**Report: Issues**

**Function: Test, Adjust, & Balance**

## CW 2999 - UTSW (DALLAS, TX)

Billingsley

**Issue Name :** VRH-3-22

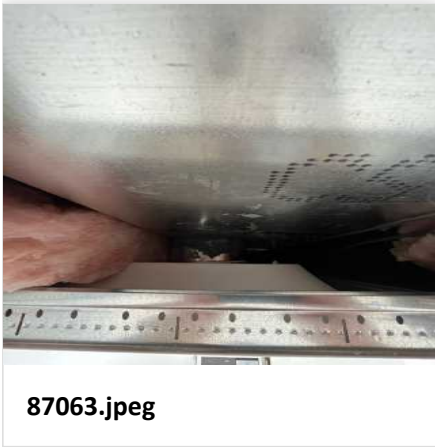
**Description :** Diffuser 4 does not have a damper and is thus extremely high on CFM. The diffusers is extremely close to the main duct as well.
